**Meeting:** 4/15/2026  
**Applicant:** Amy Sherrill Benefield Richters  
**Owner:** Break One LLC  
**Project:** 319 S. Gay St.

Staff recommends approval of Certificate 4-B-26-DT, subject to the following conditions:

**4-B-26-DT**

**APPLICATION FOR CERTIFICATE OF APPROPRIATENESS**

1 SOUTH ELEVATION - WALL AVE - DRB REVIEW  
 DRB-02 1/16" = 1'-0"

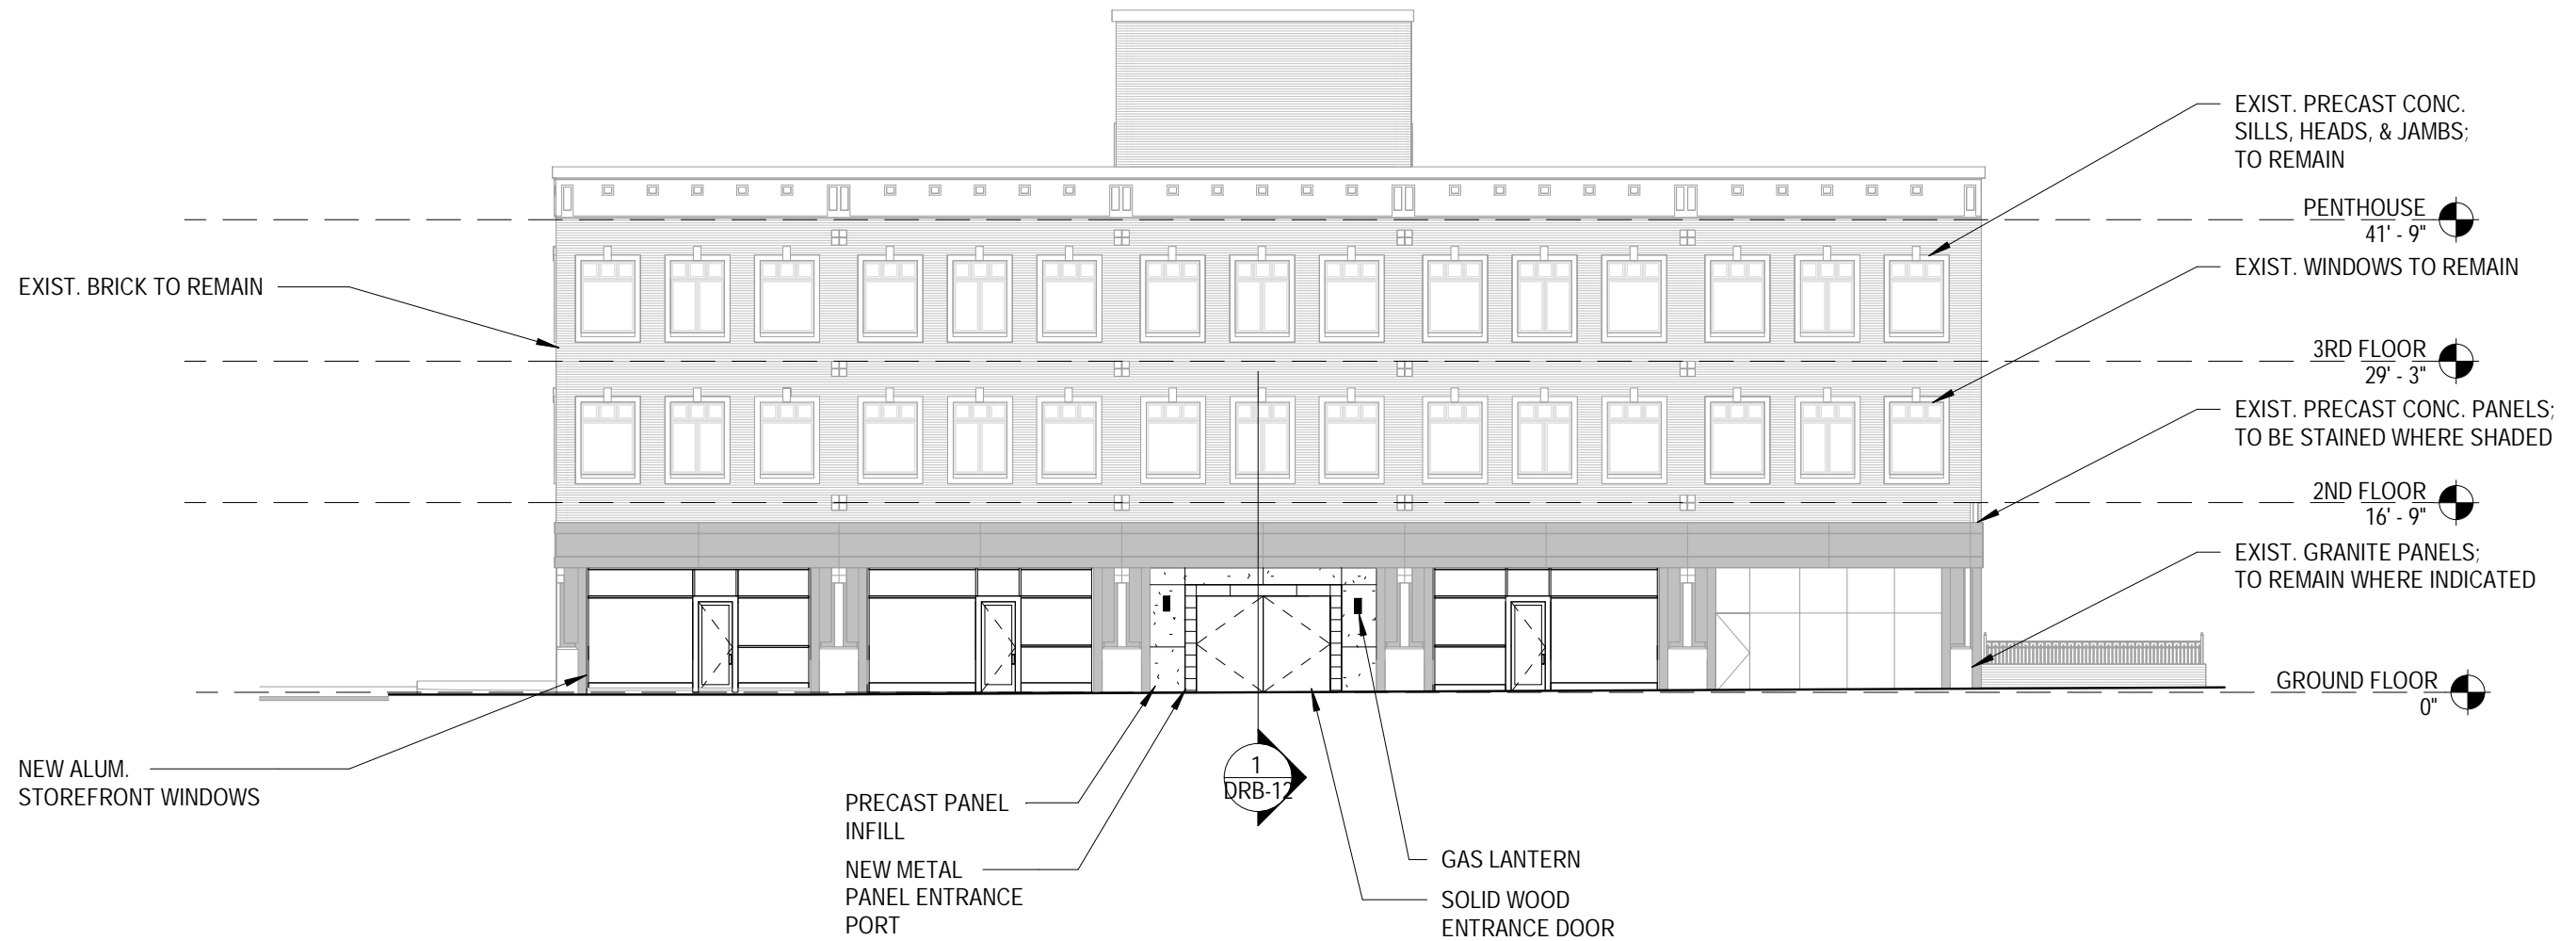
Wall Avenue elevation: The westernmost (first) bay will remain as-is, with granite panels. The second storefront bay will be replaced with a new storefront entrance featuring a wide, solid wood door, framed by an extended metal entrance port, and precast concrete panels (similar to the Gay Street entrance). The third, fourth, and sixth bays will have new black aluminum storefront systems with transoms, but no doors. The fifth bay will be replaced with new windows and single-swing doors with transoms and black aluminum frames. Precast infill panels are to be installed to cover the wall openings above the lintel of two bays with entry doors. The upper stories will remain as-is.

NOTE: The granite panels in the first bay were previously proposed for partial removal and the installation of a storefront system with a door. The second bay featured a solid wood, double door. And the third and fourth bays previously had doors. Modifications to the upper floors were removed from the scope of work.

Renovating storefronts on the first story will enhance pedestrian interest and engagement at the site. However, the proposed wide, solid-wood doors and solid-panel infill are inconsistent with the guidelines' recommendations to "enhance pedestrian interest in commercial and office buildings by creating a largely transparent and consistent rhythm of entrances and windows." The Board previously approved the storefronts, subject to the final door design being returned to the Board for approval, and with the understanding that during hours of operation, the solid doors will remain in the open position, resulting in the transparency intended by the design guidelines.

- 1) All windows at the pedestrian level are to be clear.
  - 2) Windows are to be constructed as depicted. Any changes to the proposed windows must be approved by the Board.
  - 3) The final design of the solid wood entry doors in the Gay Street and Wall Avenue elevations shall return to the Board for review and approval.
  - 4) All existing and new signs are subject to DRB review and approval as part of a separate application. Existing signs may be required to be removed and/or replaced with signs that are consistent with the guidelines.
-

1 EAST ELEVATION - GAY STREET - DRB REVIEW  
 DRB-04 1/16" = 1'-0"

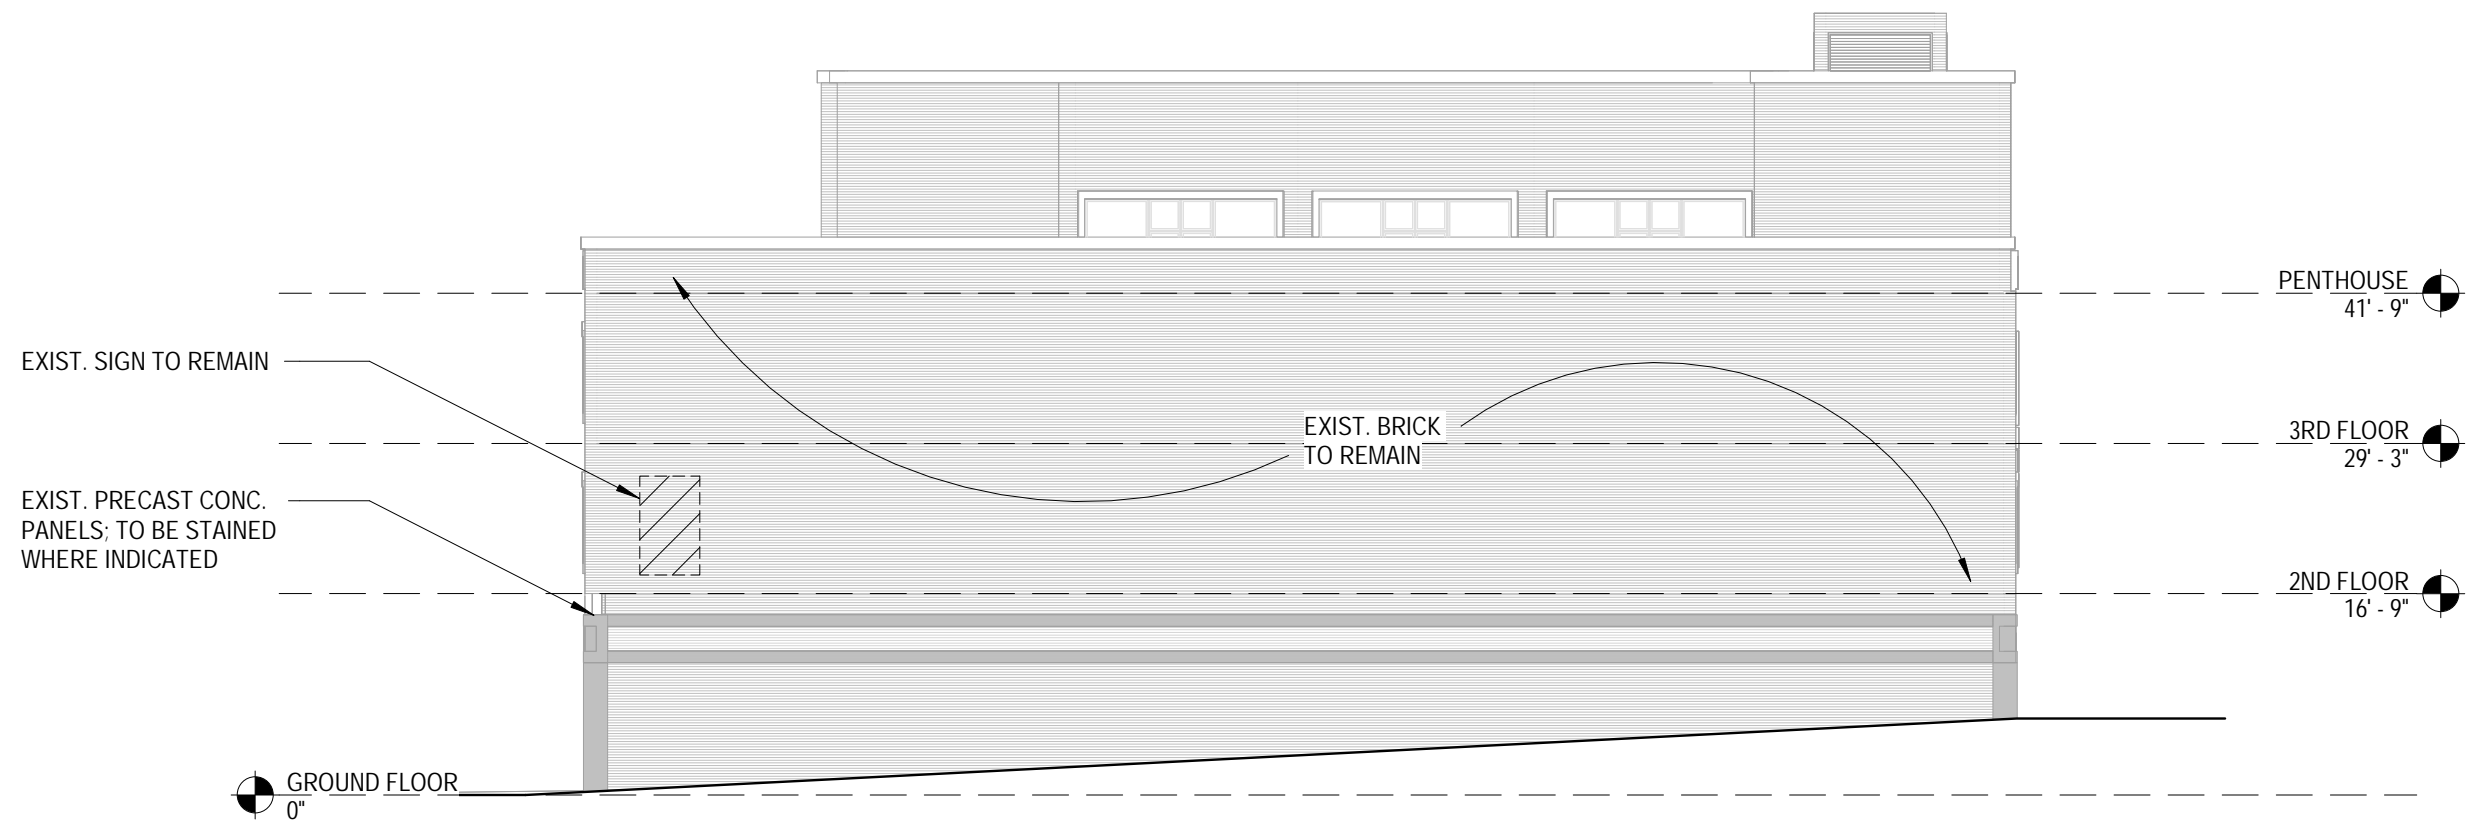
Gay Street elevation: Three storefront bays (the first, second, and fourth) will be replaced with new windows and single-swing doors with transoms and black aluminum frames. The center (third) bay will be replaced with a new storefront entrance featuring a wide, solid wood door framed by extended metal and precast concrete panels, with natural gas lanterns on both sides of the door. The door and wall area with granite accents on the northmost (fifth) bay will remain. The decorative grills under the beams are to be removed from all bays. The upper stories will remain as-is.

1 WEST ELEVATION - STRONG STREET - DRB REVIEW  
 DRB-08 1/16" = 1'-0"

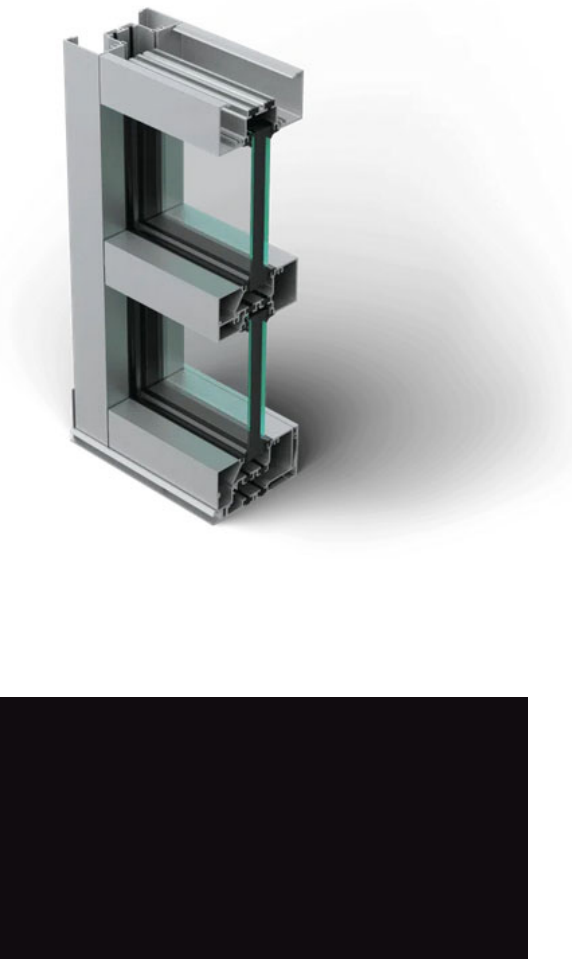
Strong Street elevation: Two new awning windows to match the existing ones are to be installed on the north side of the elevation. The sill, lintel, and jambs are to be precast concrete to match the existing.

The window installation on the Strong Street elevation creates a "largely consistent rhythm," as recommended by the guidelines. The new awning windows and precast sill, head, and jambs will match the existing, creating a cohesive look.
